Architectural Review Board Staff Report

Project Type: Amended Architectural Elevations

Description: **Gateway Studios, Lot 1A:** Amended Architectural Elevations and Architect's Statement of Design for a 19.3-acre tract of land zoned "PC" Planned Commercial District located on the north side of Chesterfield Airport Road and east of Spirit of St. Louis Boulevard.

Figure 3: Replaced Curtain wall on west

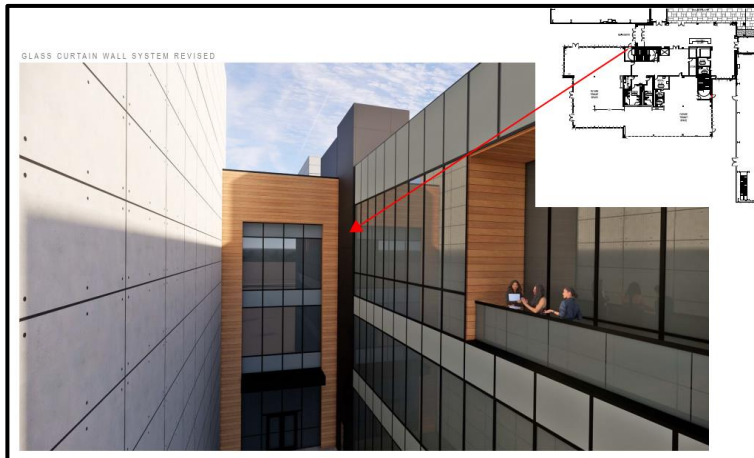
The Studio and the Office building of Gateway Studios is under construction. Applicant has submitted Amended Architectural Elevations to include the roof top mechanical equipment screening wall on the building. The tallest screening will be 17’ high that will be visible from west and north side of the building. Additionally, the proposed curtain walls on the west and south interior walls will be replaced by ACM paneling which is similar to the roof deck area as shown in figure 3 and 4.

GATEWAY STUDIOS | REVISED RENDERINGS

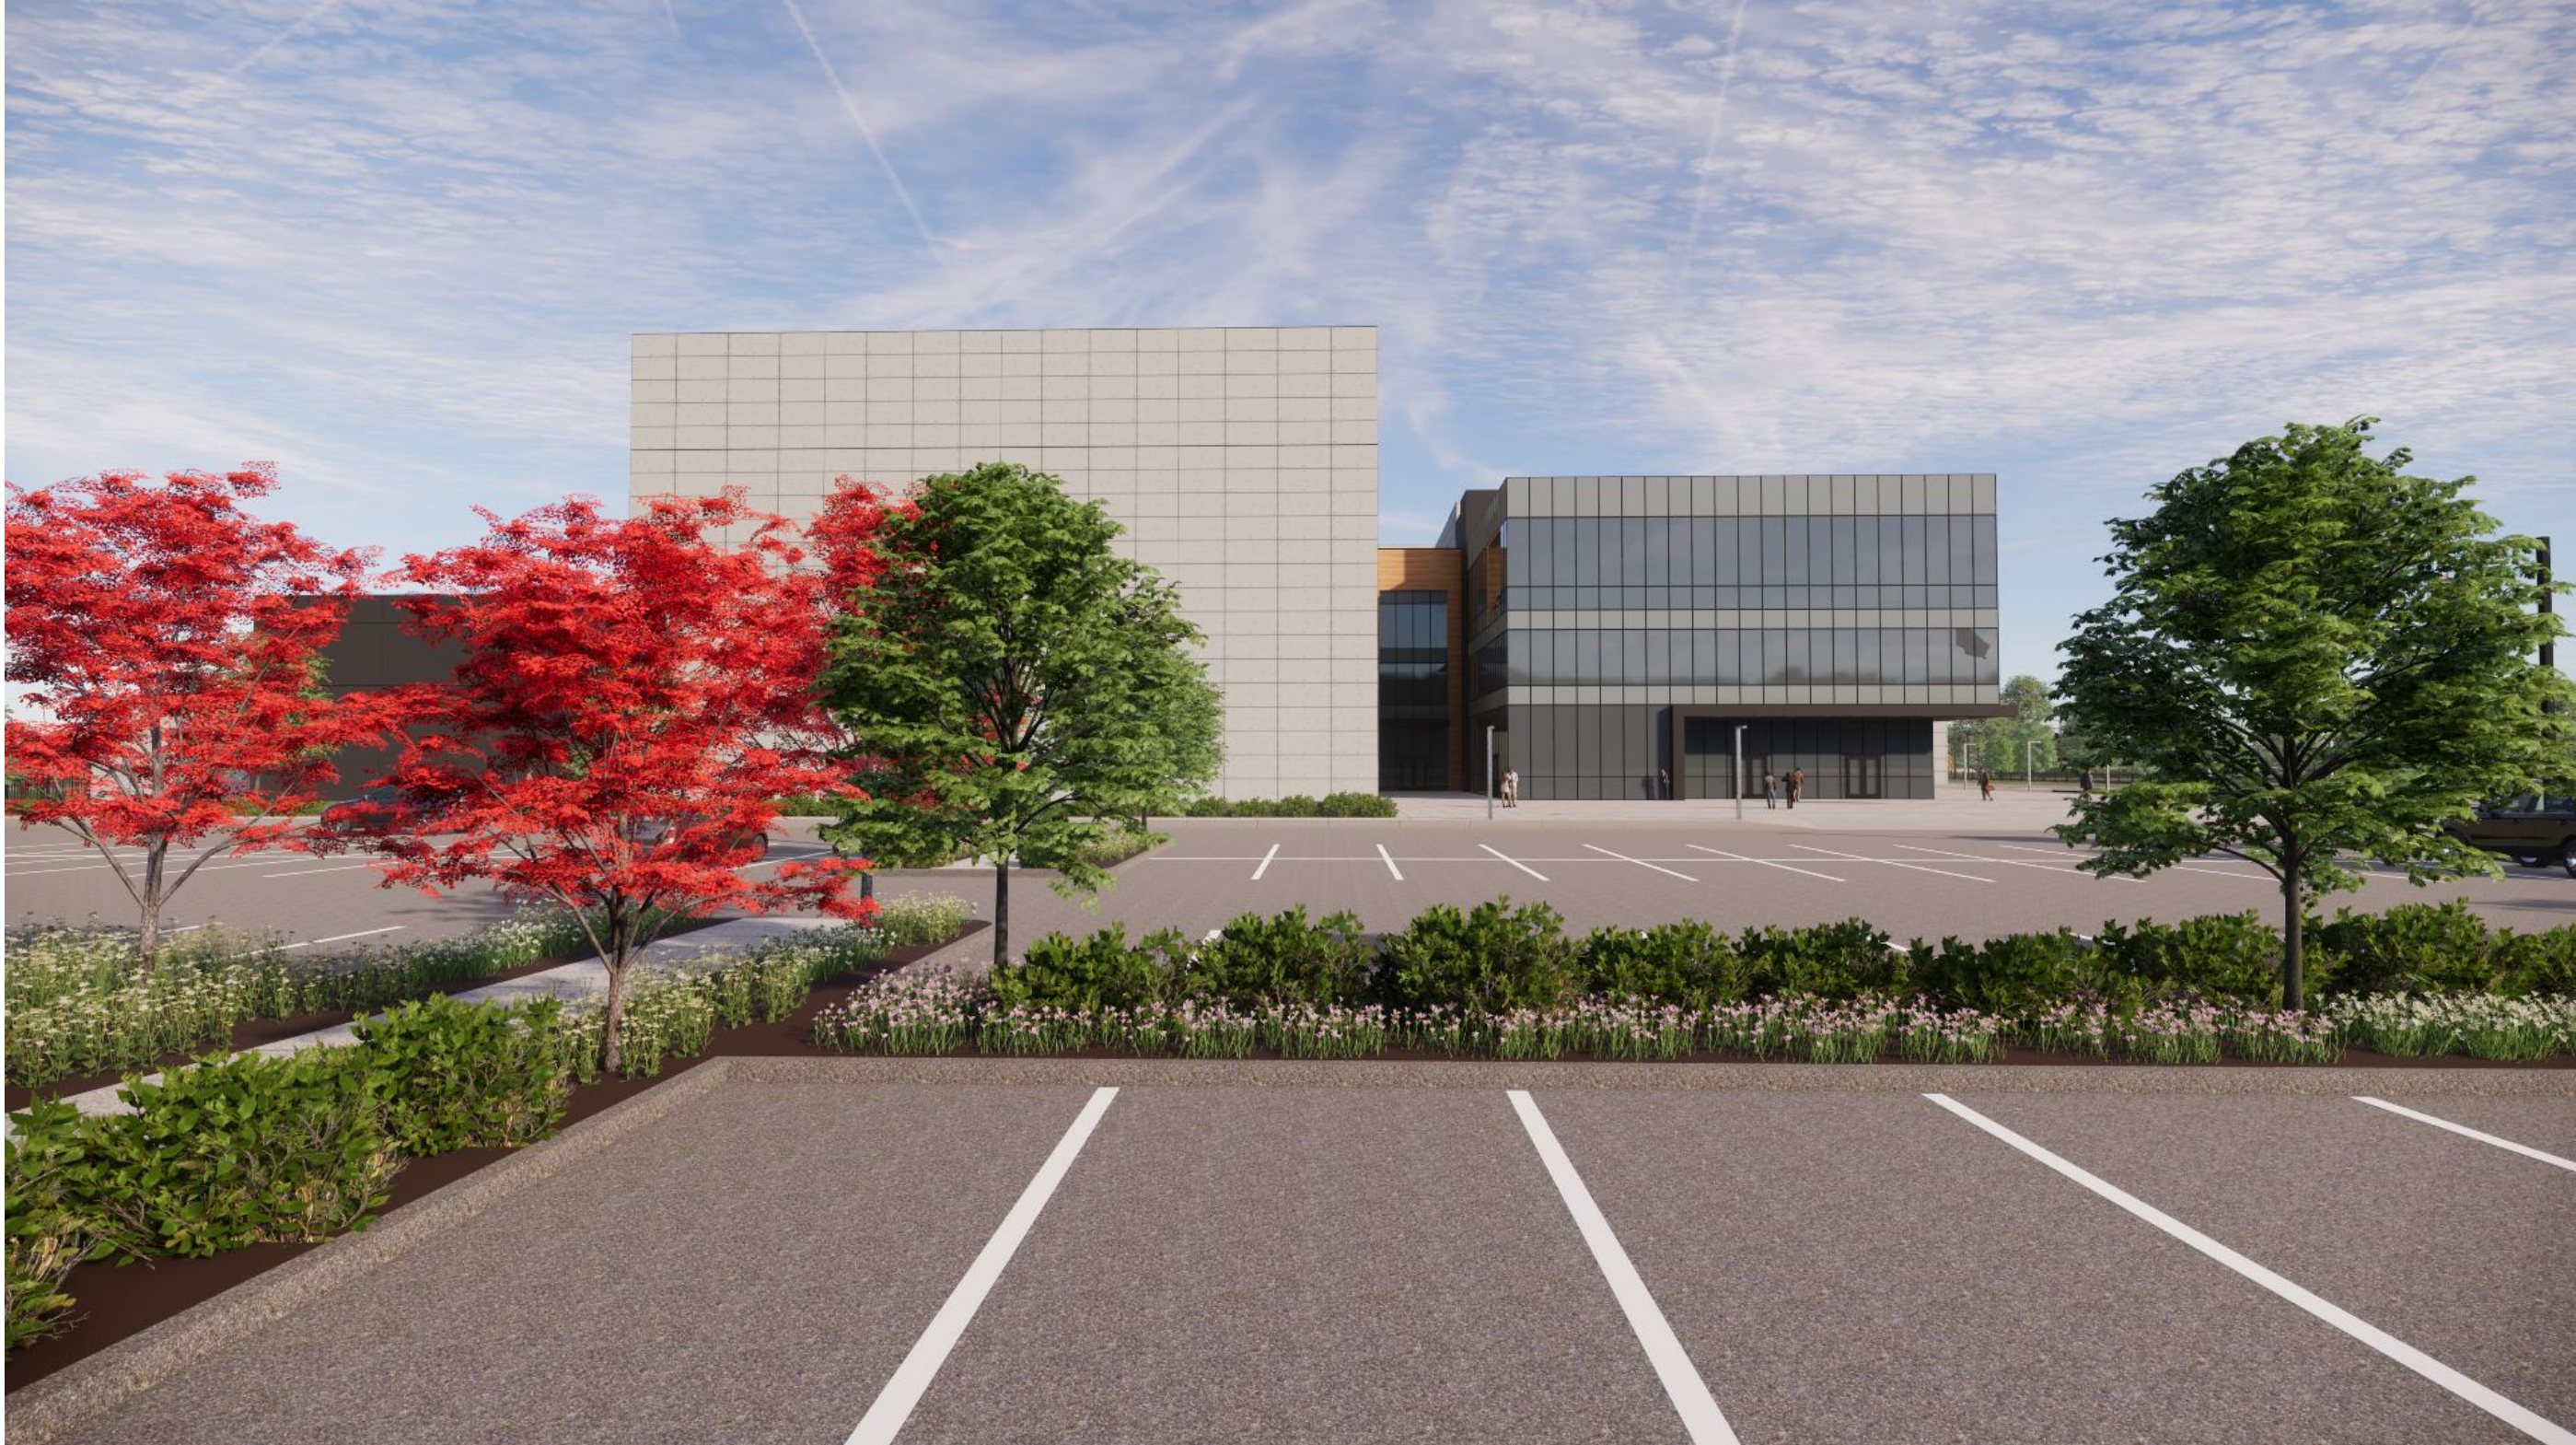
GLASS CURTAIN WALL SYSTEM REVISED
